Item #8
MCPB
11/13/03

FINAL WATER QUALITY APPROVAL FOR SPECIAL PROTECTION AREA

SUBJECT: Final Water Quality Plan for Summerfield Crossing - Site Plan # 8-03034

Re: Final Water Quality Plan for Summerfield
Crossing (Lithicum Property East)
SM File #: 204188
Preliminary Plan No.: 1-02015
Tract Size, Zone: 127 Ac., R-200/MPDU
Tax Plate: EV 562
Watershed: Little Seneca Creek

PROJECT DESCRIPTION: Proposal

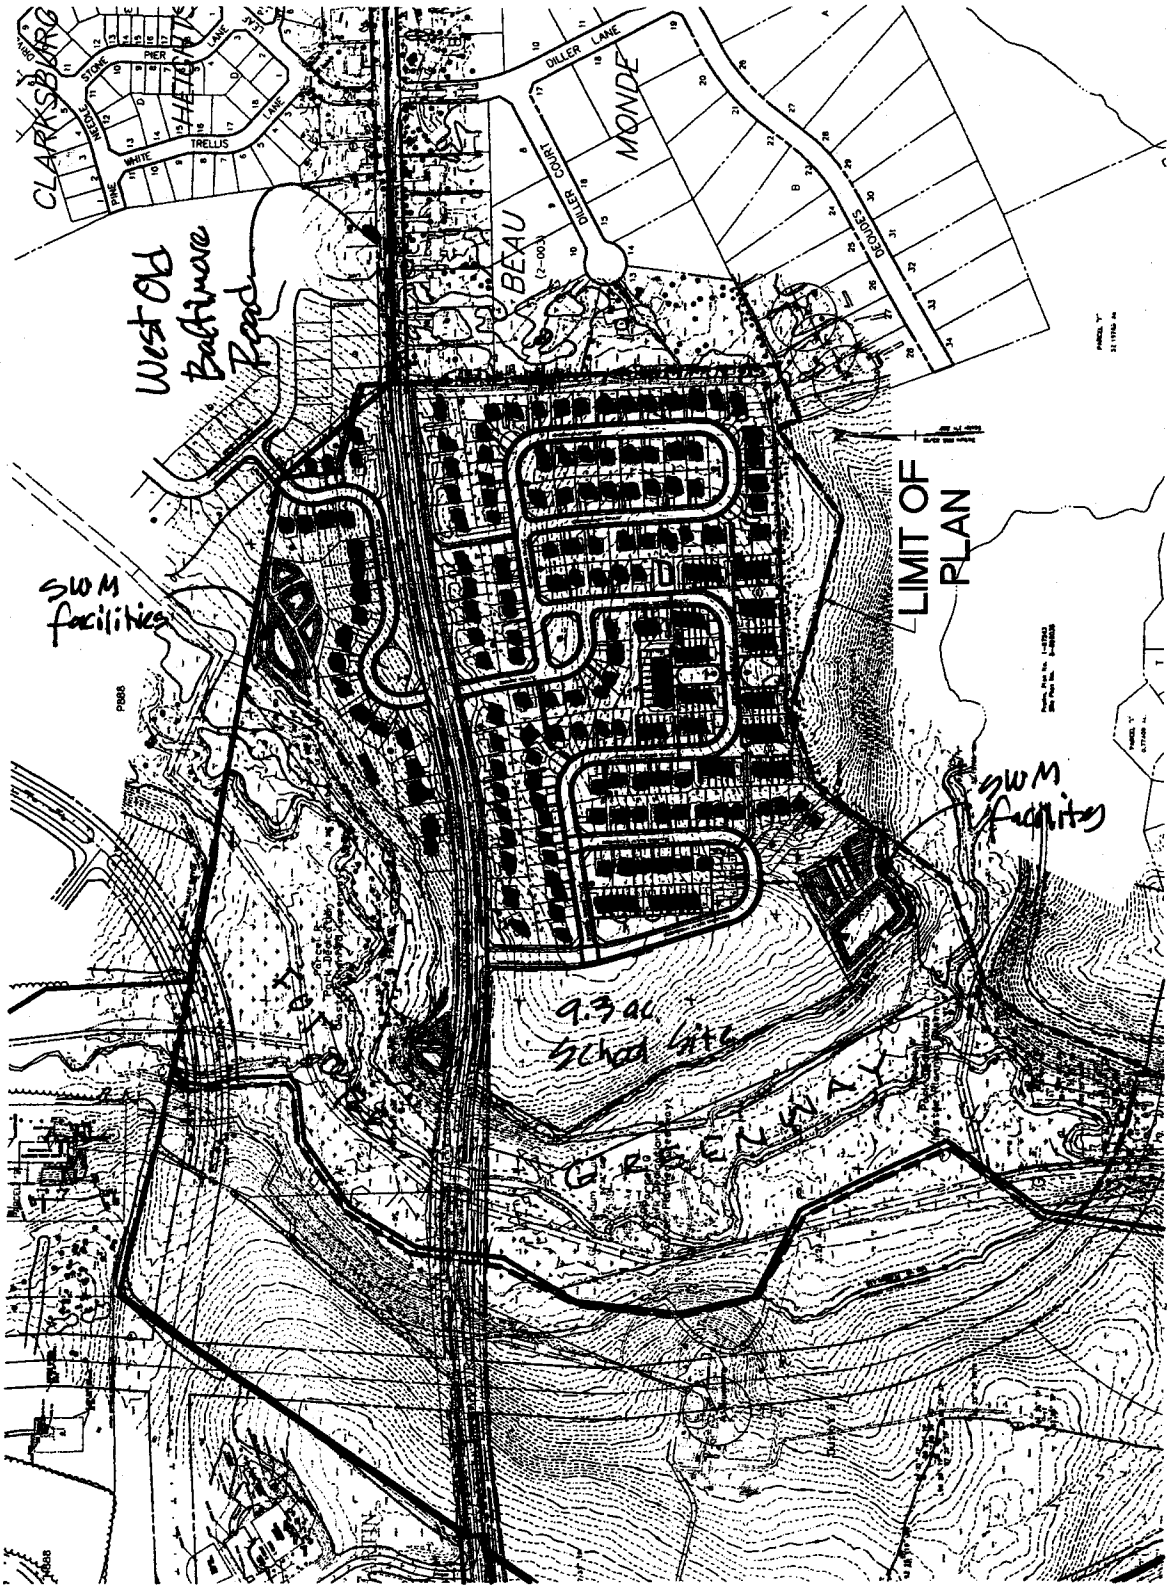
Lighting Plans need to include further detail for the townhome area lighting to insure compatibility with adjacent Single Family Detached housing; a point to point foot-candle breakdown is required and lighting fixtures need to be identified.
